# SES SOLAR ONE

## Supplemental Information In Response to CEC Data Adequacy Requests Application for Certification (08-AFC-13)

April 2009

**SES Solar One**  
**Supplemental Information**  
**In Response to CEC Data Adequacy Requests**  
**08-AFC-13**

VIS-1

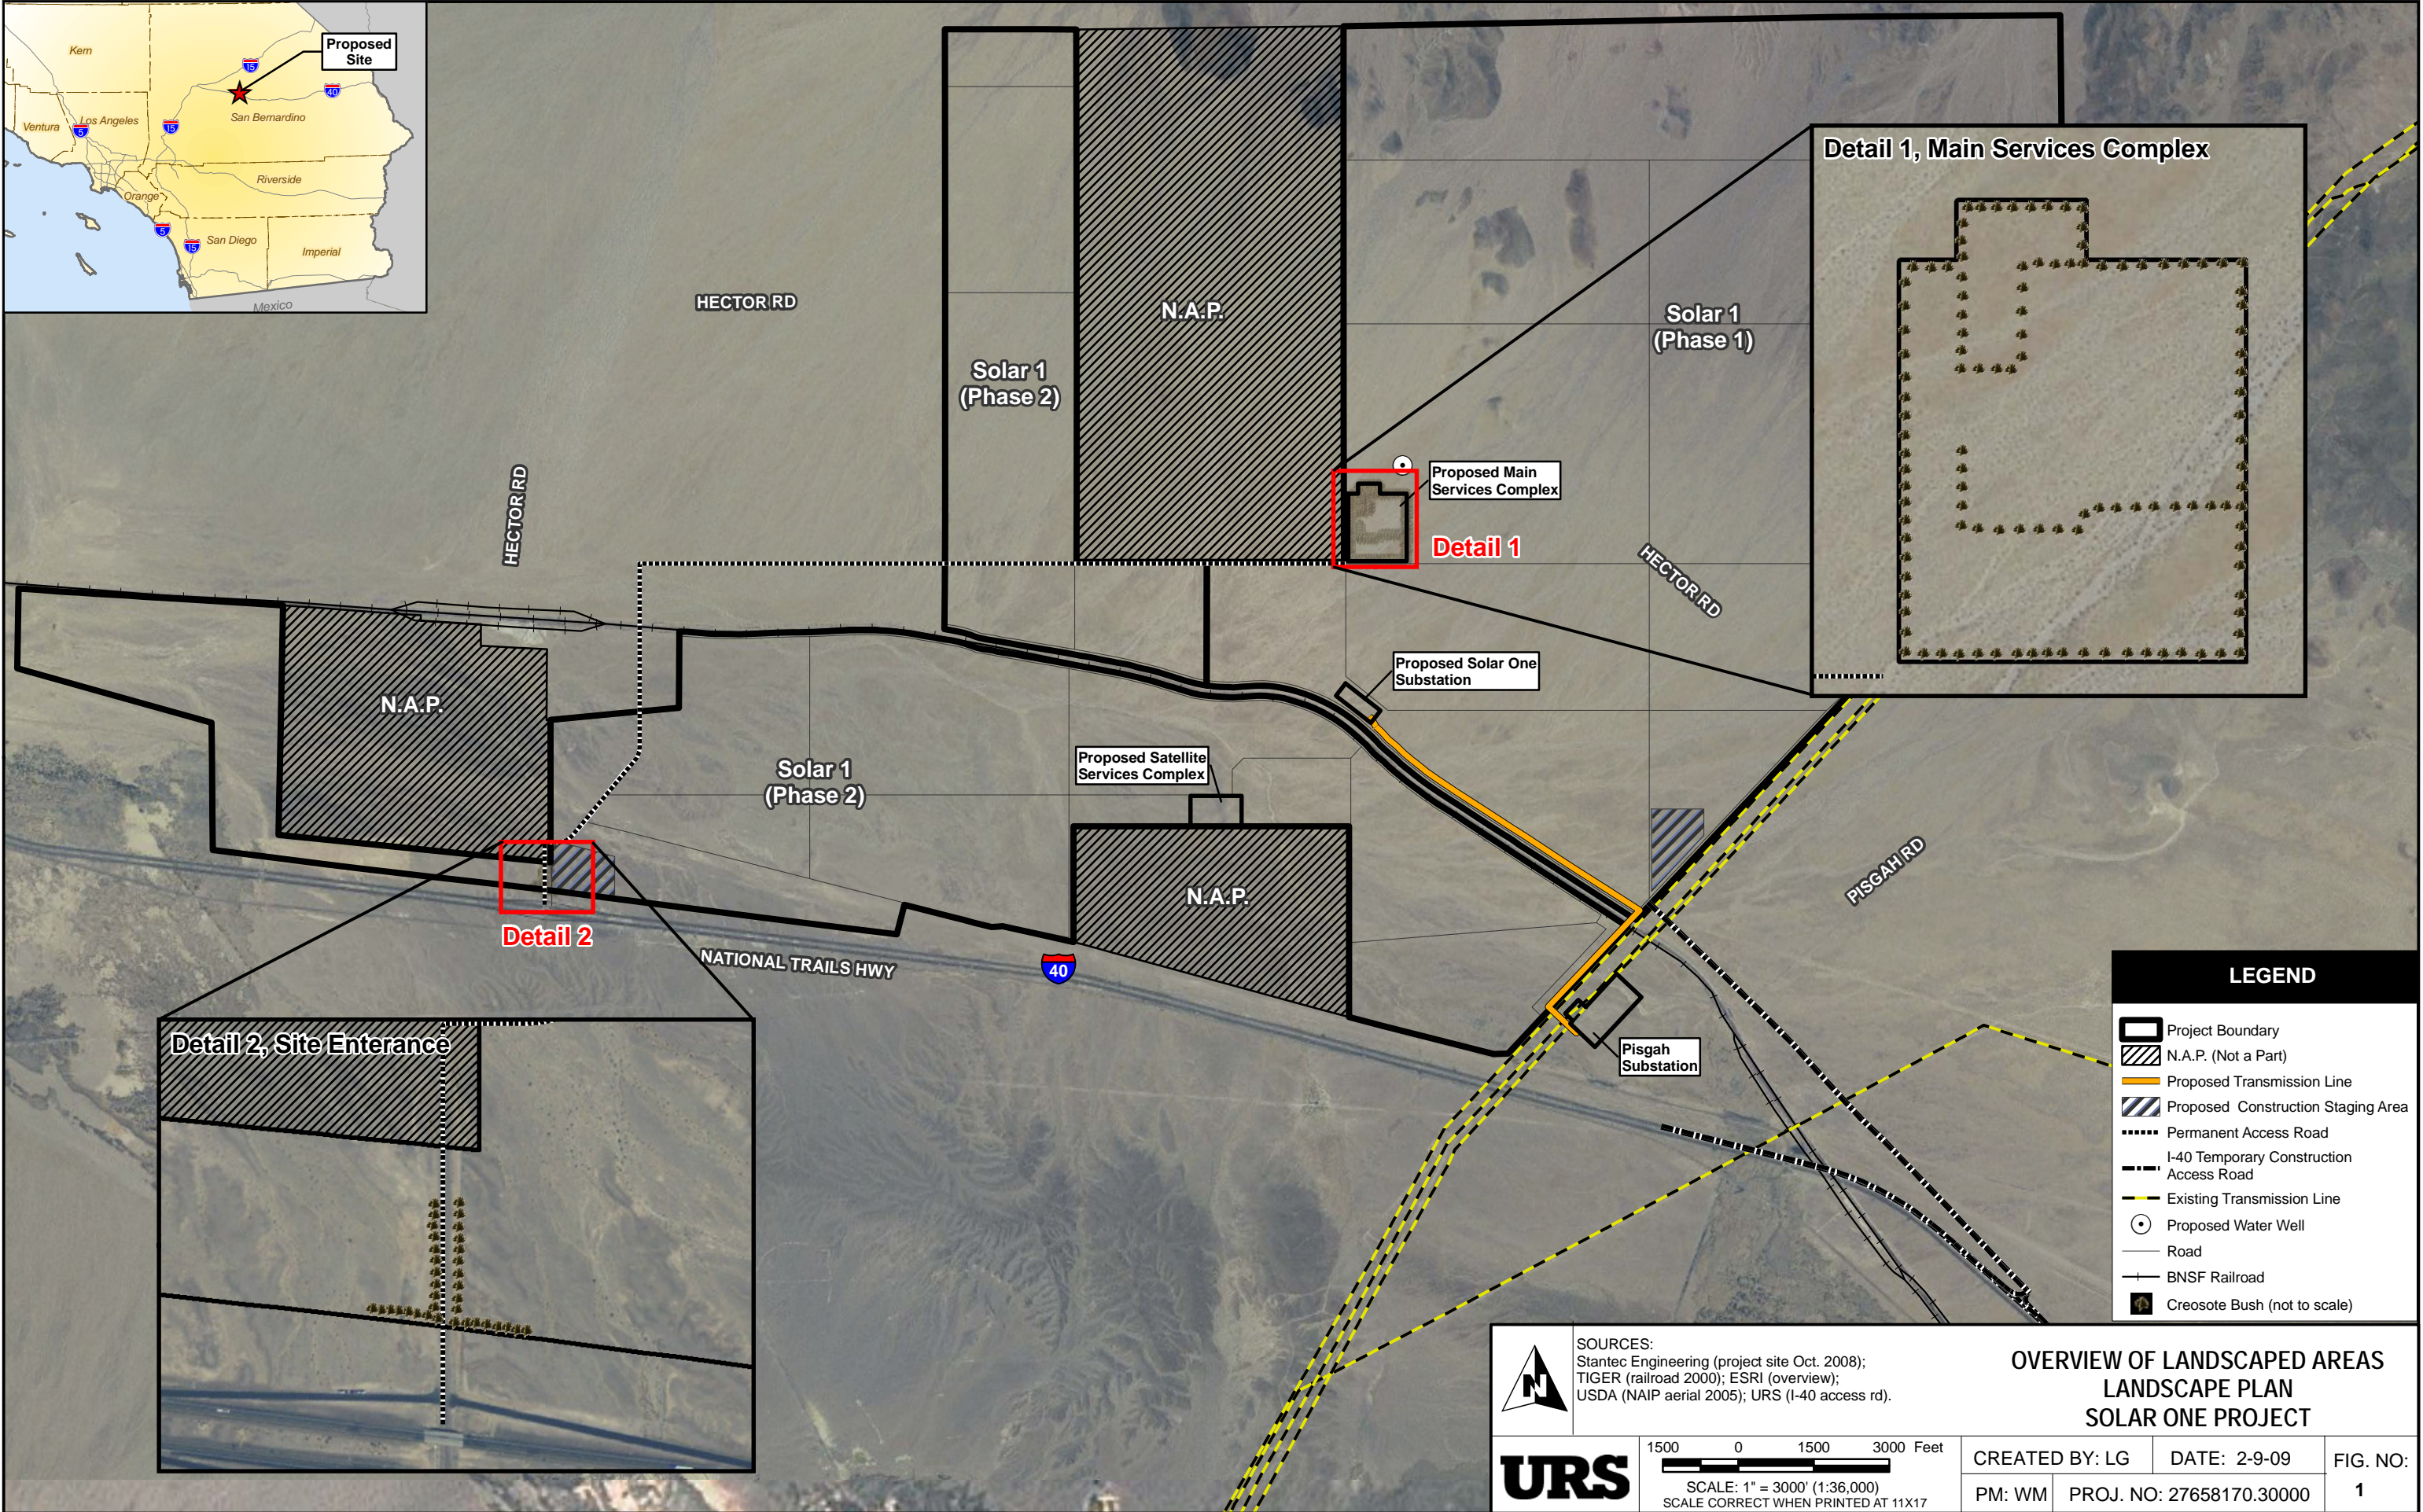
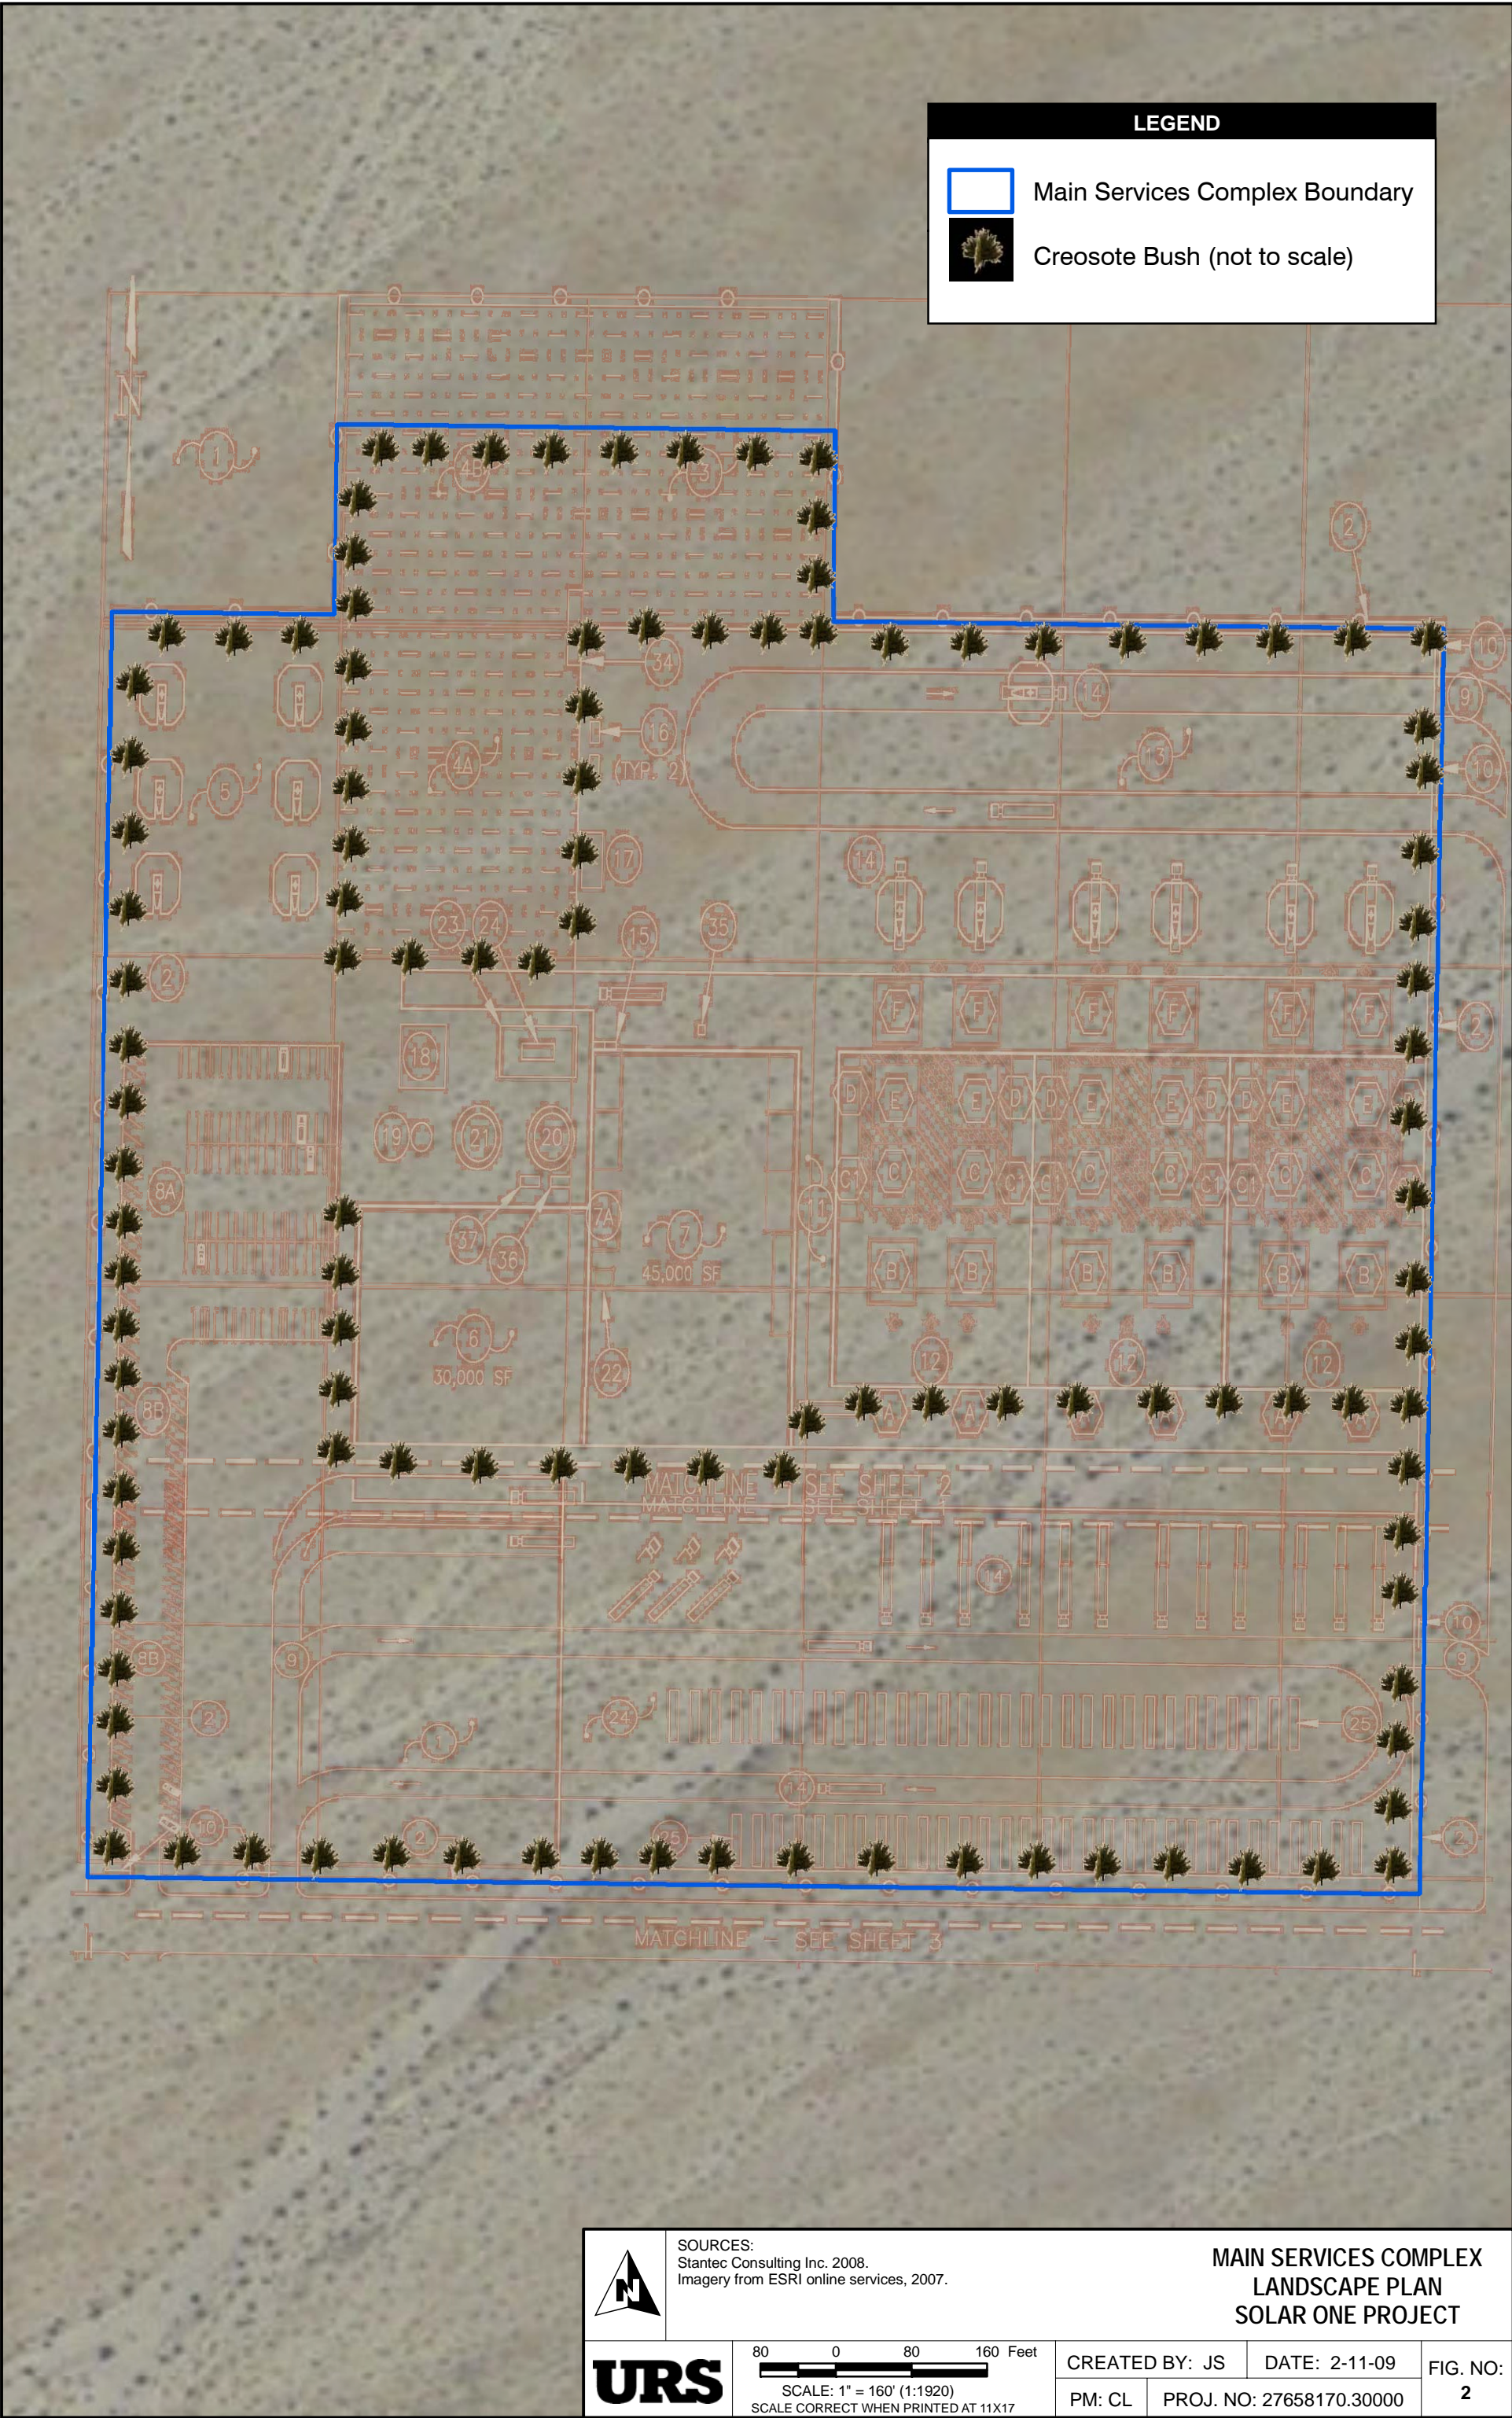
**Data Adequacy Request 45.** The applicant is proposing a conceptual landscaping plan to mitigate visual impacts. Please include the landscaping in simulation(s) representing sensitive area views, depicting the landscaping five years after installation; and estimate the expected time until maturity is reached.

**Response:** The landscaping plan, provided as attachment VIS-1 will include native creosote bushes that will be planted around the main services complex and entrance only. The landscaping will not be visible from the road or any of the KOP locations. However, the proposed landscaping plan will allow the Main Services Complex and access roads a degree of visual harmony with the surroundings. A simulation of the landscaping plan would not alter any of the photos taken for the project. Therefore, none of the simulations have been revised.
